Cross River Rail project

Coordinator-General's change report – design refinements and condition changes 2020

July 2020

Figure 4.1 Mayne Yard stormwater outlets

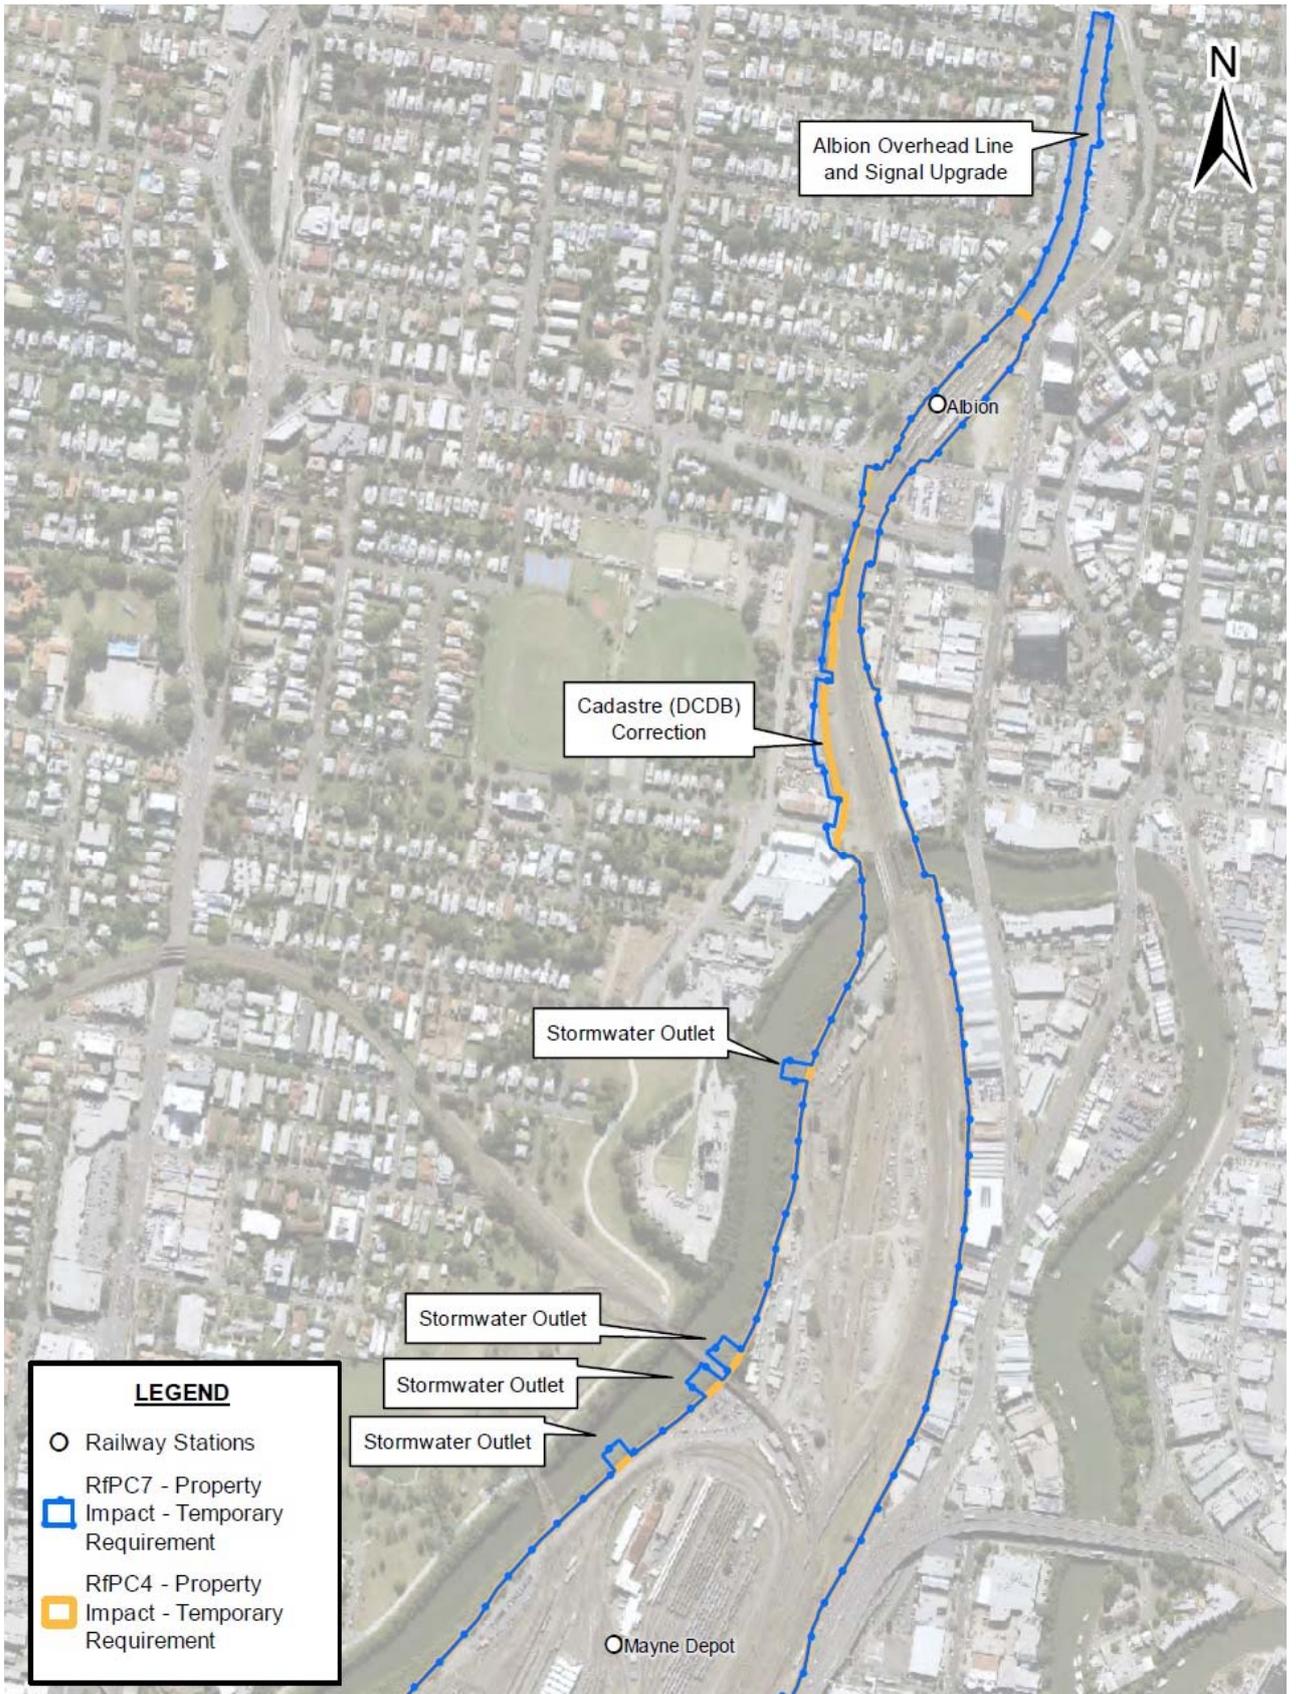
The proponent has requested the project boundary be amended to allow for the change in location and construction worksite of four stormwater outlets on the banks of Breakfast Creek, along the western boundary of Mayne Rail Yard, Lot 1RP892797. Refer to Figure 4.1.

The proposed change in location of the stormwater outlets is to ensure stormwater runoff is discharged from the lowest point of the Mayne Yard catchment. Due to the low-lying topography within Mayne Yard it is not possible to accommodate the stormwater outlets within the existing project boundary.

I have considered the proposed changes for the Mayne Yard stormwater outlets and I am satisfied that the project's environmental management framework consisting of the Imposed Conditions, the OEMP and CEMP are sufficient to manage the environmental impacts. I accept the proposed change to location for stormwater outlets at Mayne Yard.
